SHINE Technologies, LLC Application for an Operating License  
Supplement No. 10 and Response to Request for Additional Information

#### SHINE TECHNOLOGIES, LLC APPLICATION FOR AN OPERATING LICENSE SUPPLEMENT NO. 10 AND RESPONSE TO REQUEST FOR ADDITIONAL INFORMATION

#### **RESPONSE TO REQUEST FOR ADDITIONAL INFORMATION**

**Figure 11.1-3 – Radiation Protection Organization**

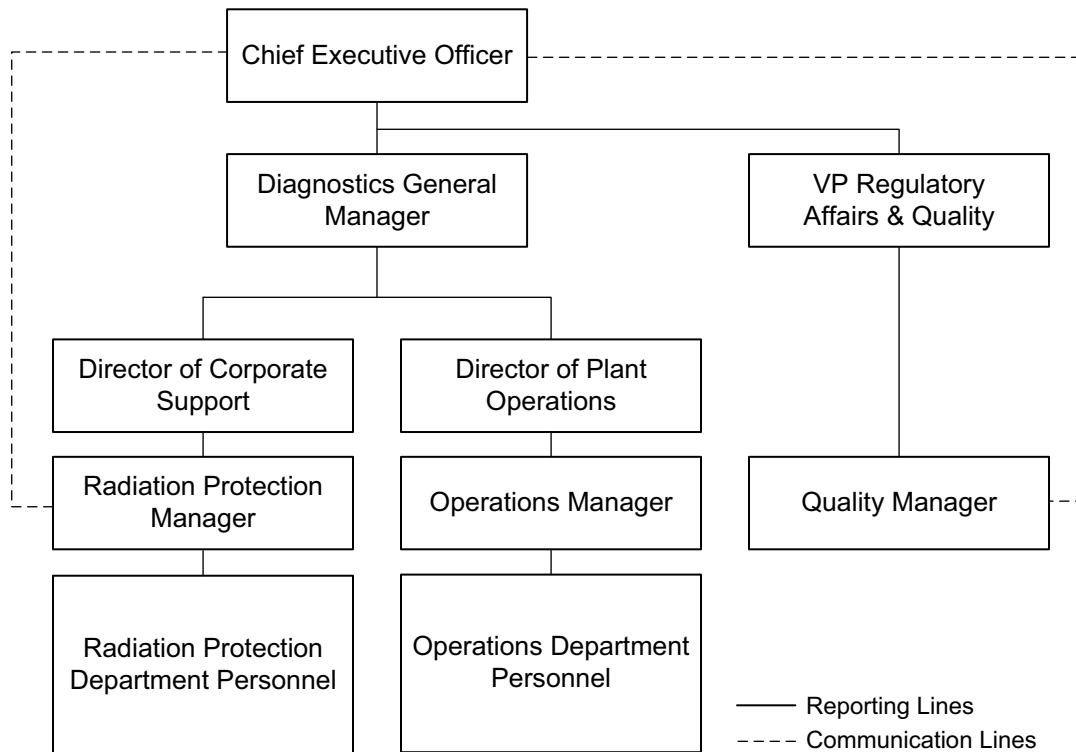
Summary Description of Changes	FSAR Impacts
Update to the organizational structure affecting titles, responsibilities, and reporting relationships.  Section 5.1, Figure 5.1.1, and Section 5.2, of the technical specifications have also been revised to incorporate these organizational structure changes.	Section 11.1, Section 11.2, Figure 11.1-3, Section 12.1, Section 12.2, and Figure 12.1-1
Update to audit activities to include nuclear criticality safety program audit requirements, consistent with Section 5.2 of the technical specifications and the SHINE Response to RAI 6b.3-18 (Reference 1).	Section 12.2

The Radiation Protection Manager is responsible for implementing the radiation protection program. The Radiation Protection Manager reports directly to the ~~Plant Manager~~DCS, independent from facility operations. The Radiation Protection Manager has direct access to executive management for matters involving radiation protection. The Radiation Protection Manager and radiation protection personnel are responsible for:

The Radiation Protection Manager reports to the ~~Plant Manager~~ DCS. The Radiation Protection Manager is responsible for establishing and maintaining the Radioactive Waste Management Program. The Radiation Protection Department maintains organizational independence from the Operations Department. The Radiation Protection Manager and Radiation Protection staff responsibilities are to:
